BOSTON EDISON

Boston Edison Company Response to
NRC Request for Additional Information
on Increasing Allowed Fuel Assembly Storage
(TAC No. M85898)

RESPONSES TO 11/15/93 NRC REQUEST FOR ADDITIONAL INFORMATION (RAI)
AND 12/9/93 TELEPHONE QUESTION FROM NRC PROJECT MANAGER

FIGURE 1: ELEVATION VIEW OF HOLTEC LIFT RIG

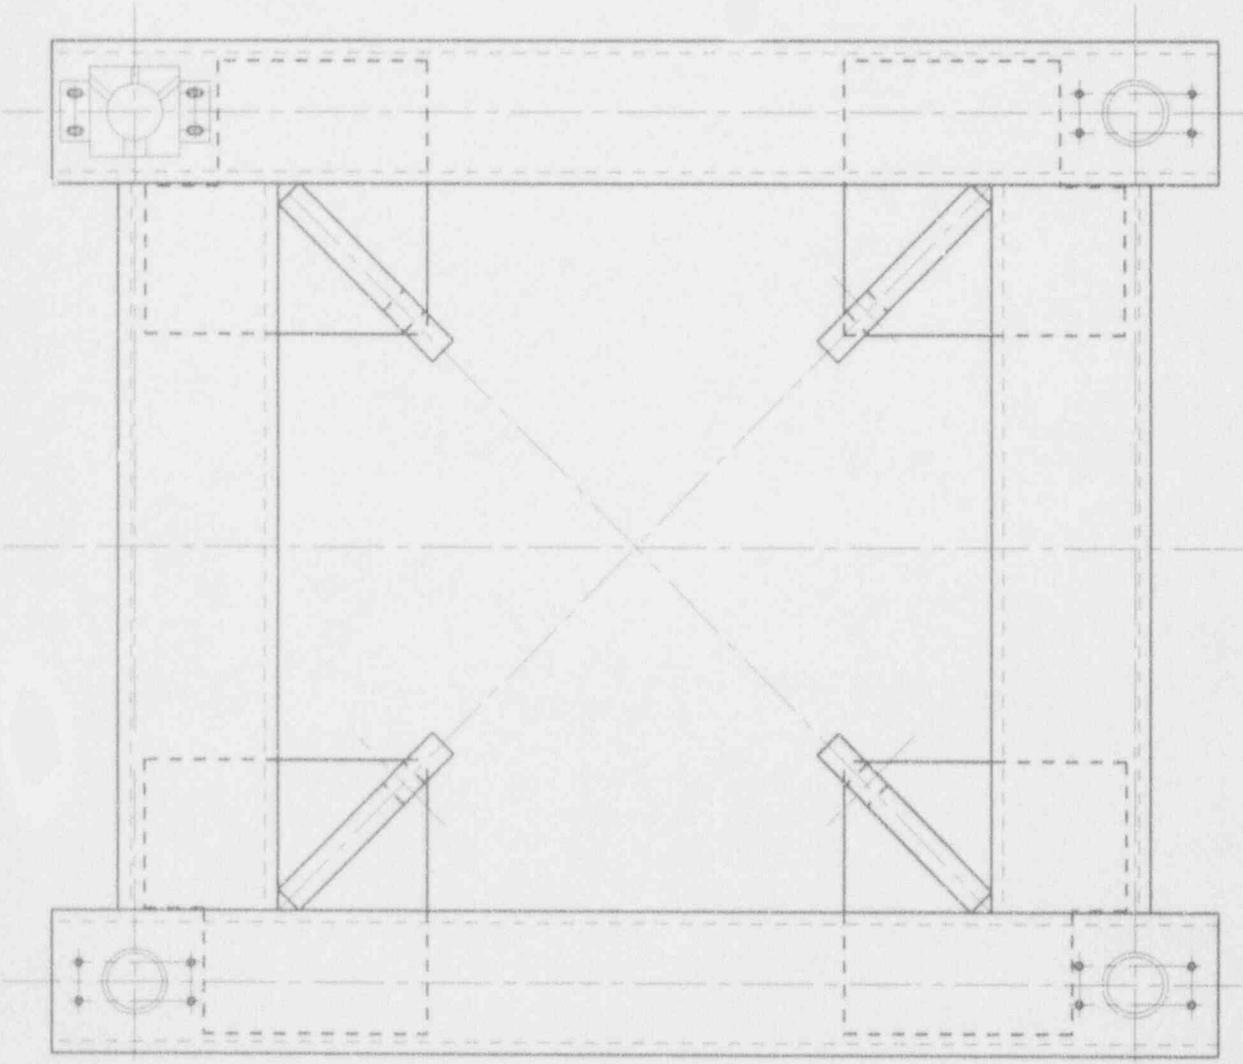
Provide a figure showing the proposed rack lift rig.

Figures 1 and 2 (attached) illustrate the Holtec lift rig design.
